**CITY OF TEMPE
DEVELOPMENT REVIEW COMMISSION**

**Meeting Date: 9/13/2016
Agenda Item: 4**

ACTION: Request for an Amended Planned Area Development Overlay and Development Plan Review for two new 24-story buildings consisting of a mixed-use 586-unit multi-family with retail and restaurant uses, and a Use Permit to allow 216 tandem parking spaces for THE PIER (PL160248), located at 1190 East Vista Del Lago Drive. The applicant is Sender Associates Chtd.

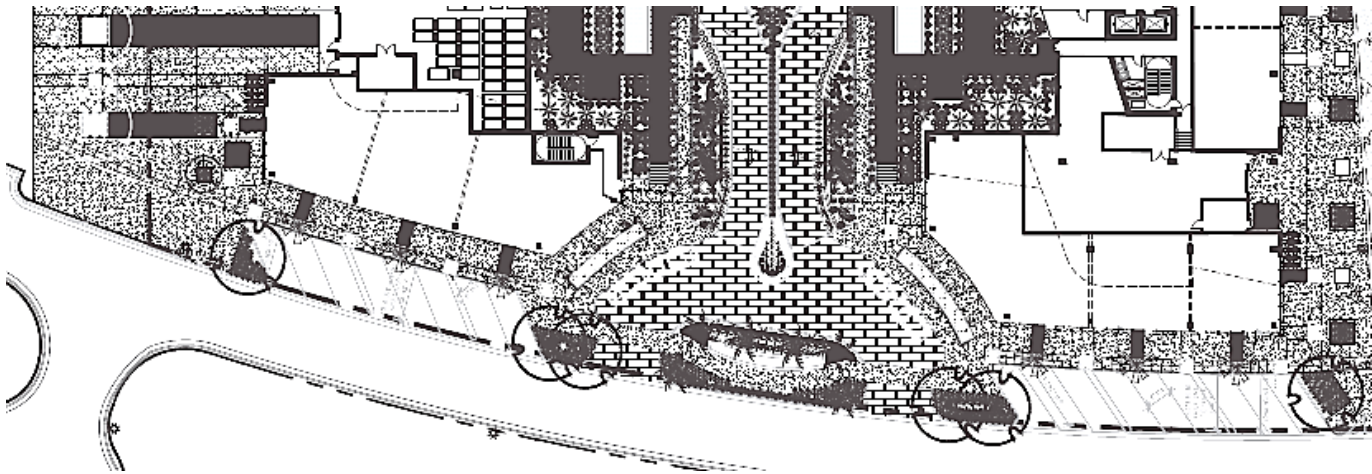
The proposed design solution (Attachment 44) is shown below. The tree planters are adjacent to the public utility easement and provide approximately 4.5' of soil depth (2 feet below grade) in planters approximately 9 feet wide by 9 feet long (5 feet of the planter box is over the public utility easement, requiring a root barrier). This solution would provide limited soil for a tree to grow. Until the understory plants mature, the mounded soil would potentially wash out during heavy rains. The trees would be limited in root area and require replanting prior to maturity, always appearing as a newly planted tree.

There is a condition of approval which would potentially impact 10 parking spaces located on the south side of Level B-1 in the garage, reducing the parking to 1,051 spaces. This reduction would allow street trees to be planted in a larger soil base, with approximately 18'x17' of surface area and 9' of soil depth, creating built in planters the full depth of the first floor of the garage, rather than the 4 foot root zone proposed in the landscape plan. This solution would require removal of parking spaces on Level B1 of the garage, for recessed (in ground) planters large enough to meet the minimum square footage area to sustain required trees to a mature size.

Below is an illustration of the approximate underground basement level impacts to parking, with the PUE shown in the first 5'

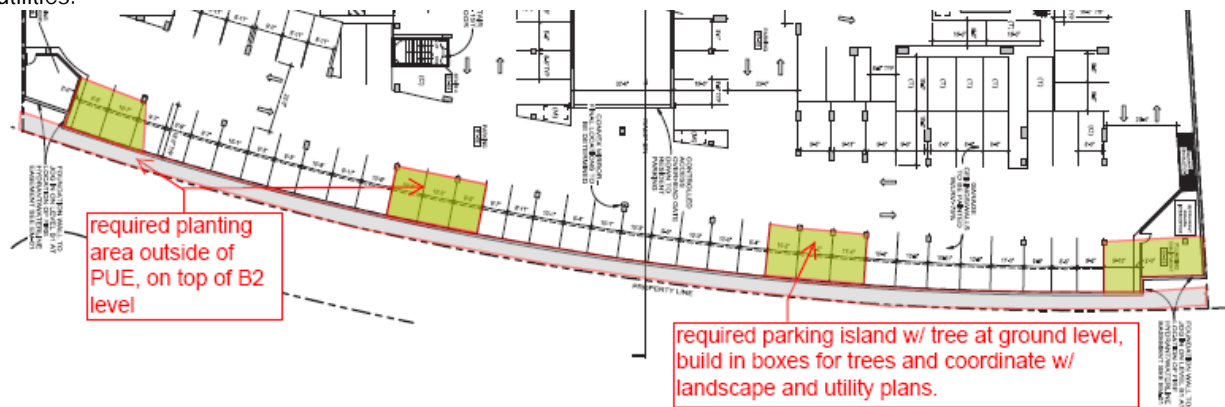
as grey. This PUE was reduced from 9' to 5' with engineering approval that no private utilities or trees be located within this area. The green areas are proposed to address requisite street tree planting areas as described below the image. This solution would allow parking spaces between 'planter' walls; subsequent lower floors would retain full use of the area for parking as proposed. Other design solutions may be feasible; therefore the condition supports other solutions that may not have been considered, as long as the public utility easement is maintained in a manner that functions for requisite public utilities.

1 SITE REFUSE DIAGRAM

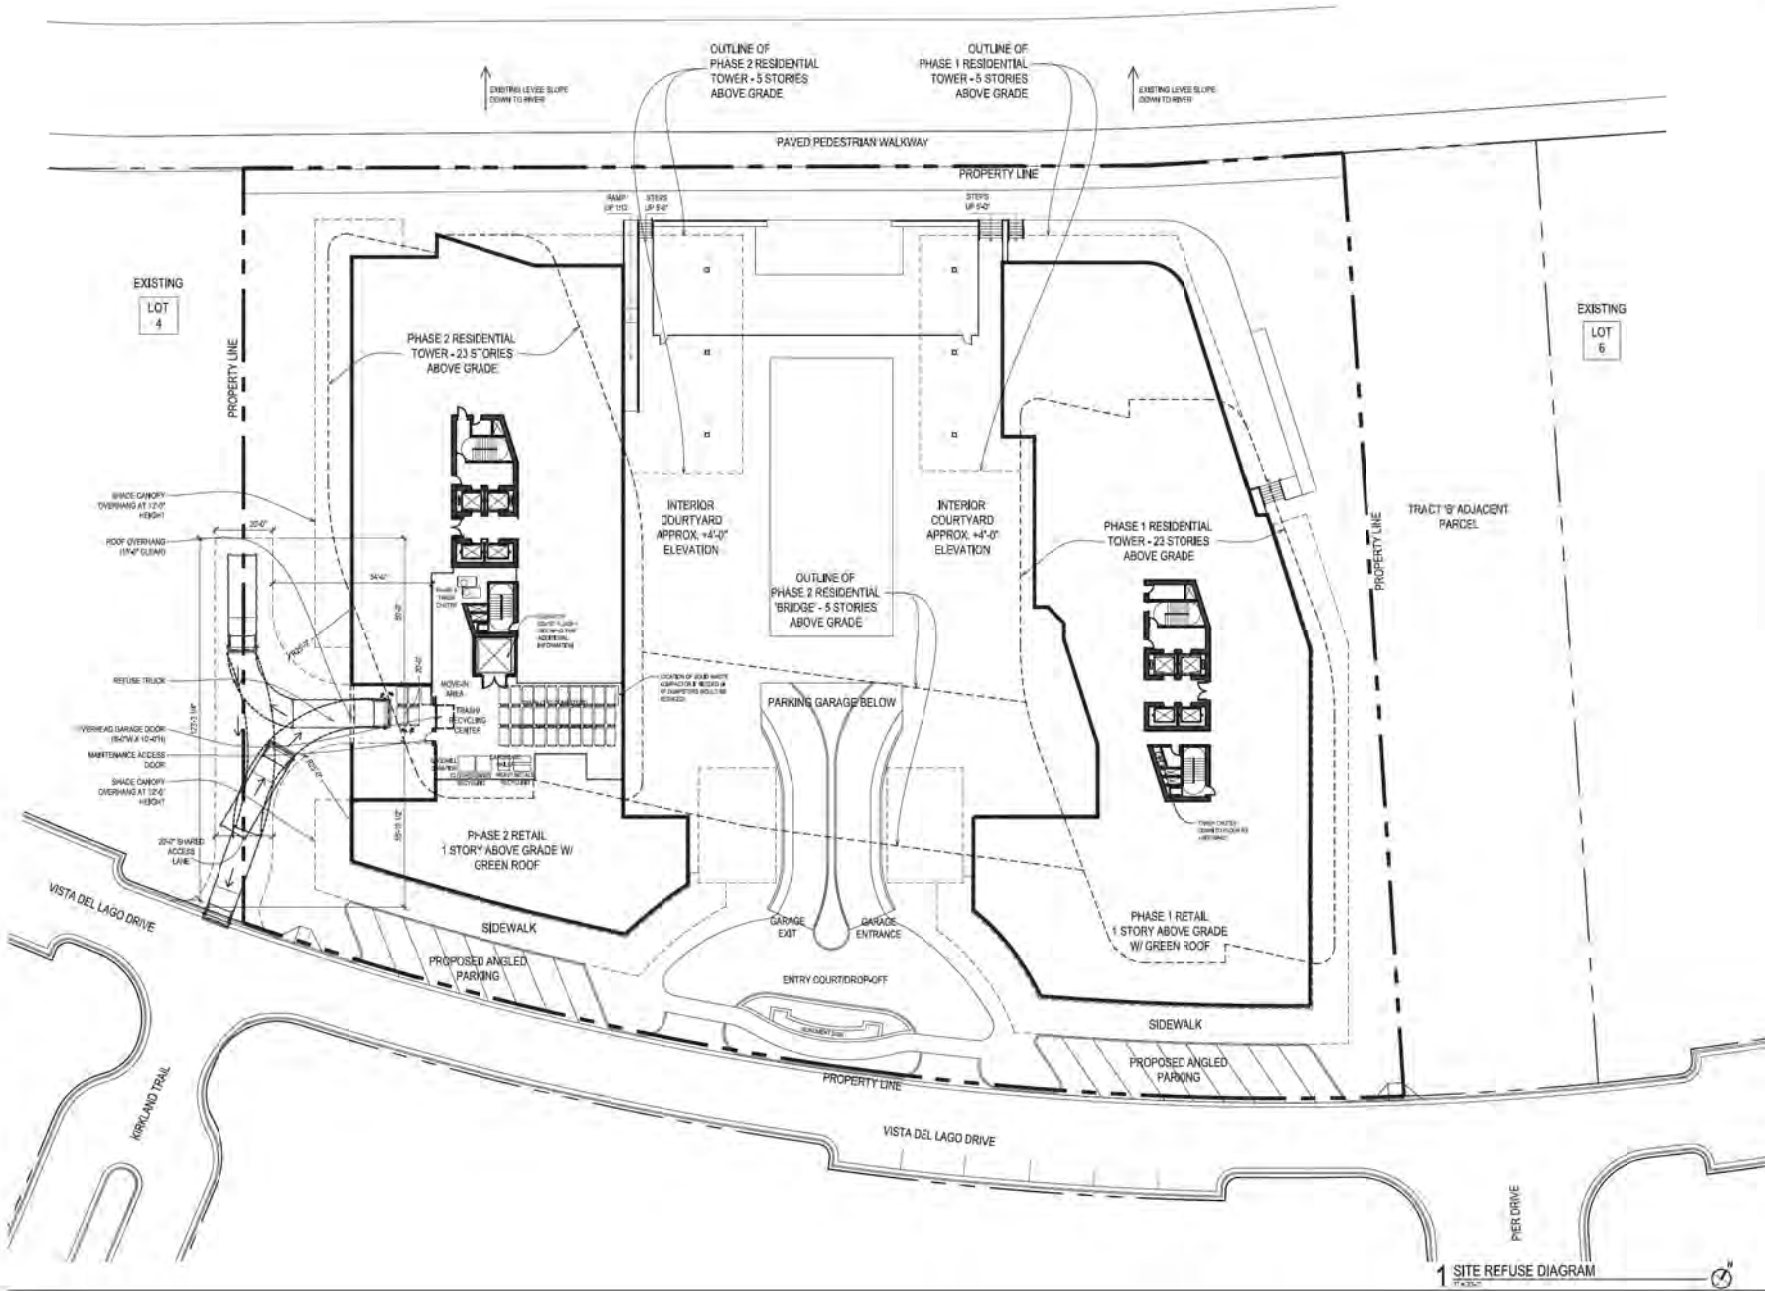
- Sanitation services has accepted the proposed plan, with the modification to sheet RP-02: refuse is not to be wheeled up the center drive aisle to the first floor, it is all to follow the shortest, safest path of travel within the

garage to the elevator per earlier conversations. Due to the proposed refuse solution, a condition has been added that requires the service elevator and refuse storage room portion of phase two tower to be constructed as part of phase one. The refuse transport and storage solution cannot be left unresolved until a future phase of development. If phase two does not occur, then the service core will need to be designed aesthetically and functionally without the second tower.

- Sheet RP-02 Refuse Diagram plan shows a refuse path up the center ramp for pick up on first floor, this is not an approved refuse collection solution. All refuse shall be collected in bins and transported to the service elevator in tower 2 for collection at the service entrance to the building.

2 SECTION AT PLANTER - SOUTH SIDE OF SITE

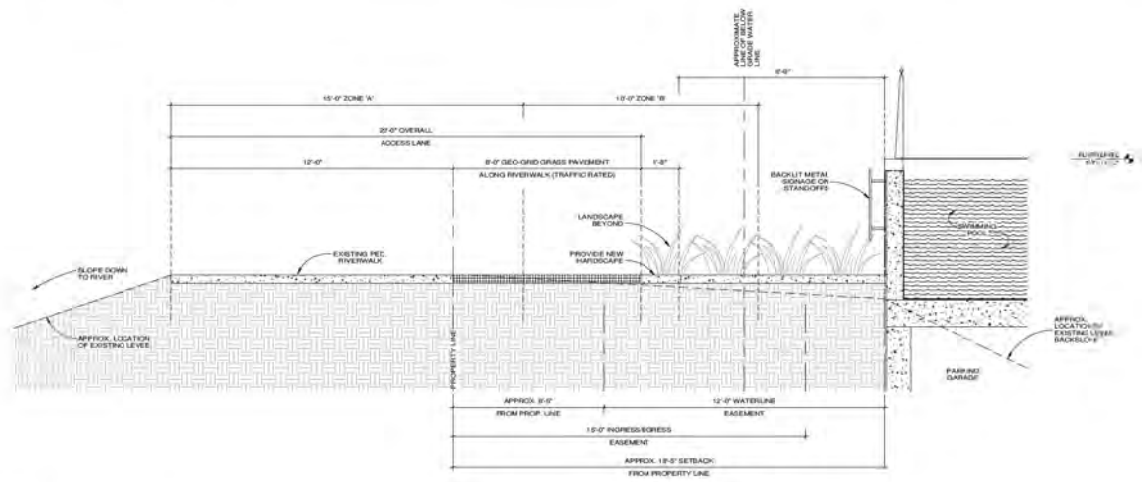
- Street trees and landscape island trees are provided in planters that are 2' above grade and 2' below grade, providing a 4' soil depth to meet street tree requirements (staff included a condition for the prior entitlement that trees be planted in ground, not in boxes).

- Staff asked for further landscape details on the boxed street tree solution, a detail was provided.
- Plans were not rotated with north to the top of the page, some sheets were and others were not, staff requested that all submitted pages match the original orientation for comparison between existing entitlement and requested changes.
